Product Change Notification

PCN #: 20211108-02

Change Title: Modification of the AZEV116, AZEV132 and AZEV140 series relays.
1.) Armature set assembly.
2.) Coil terminal coating.

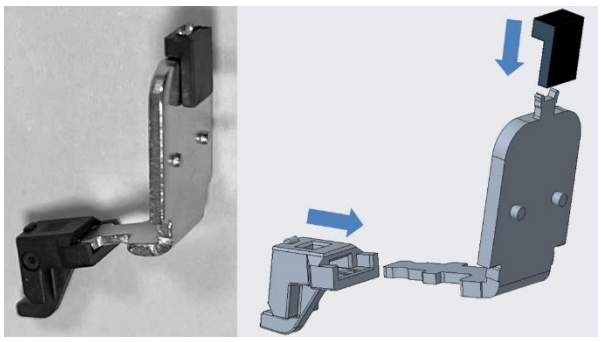
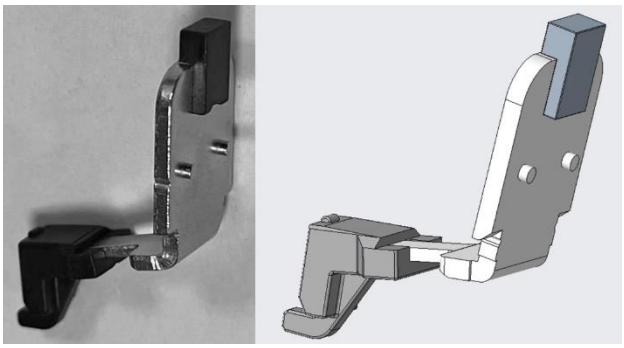
1.) Armature set assembly.
- **The armature set assembly will be changed from 3-part to one-piece molded part.**
- **This change has no impact on the product performance.**

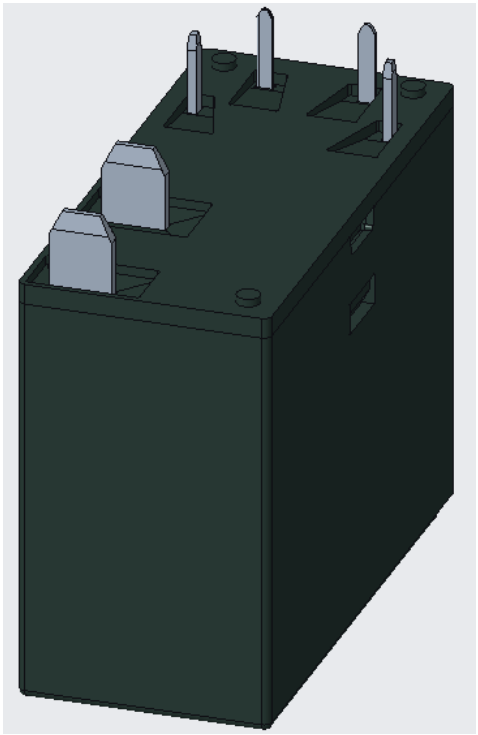
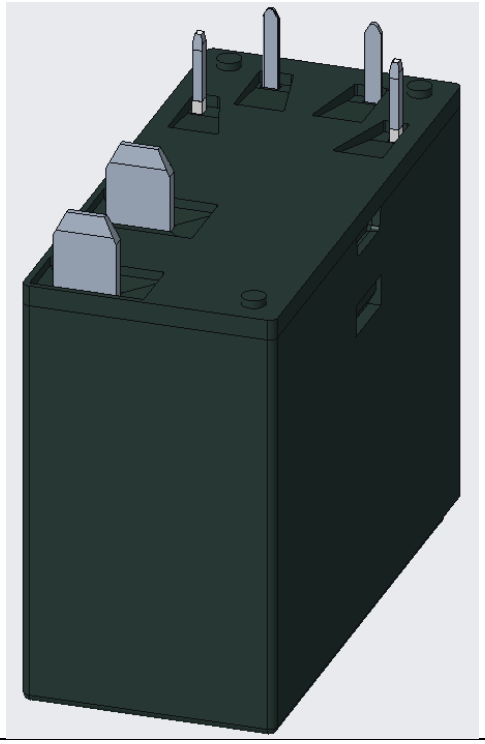
2.) Coil terminal coating.
- **The coil terminals will not be electroplated in the future. Instead, the terminals of the finished product are tinned in a separate process.**
- **This change has no impact on the product performance.**
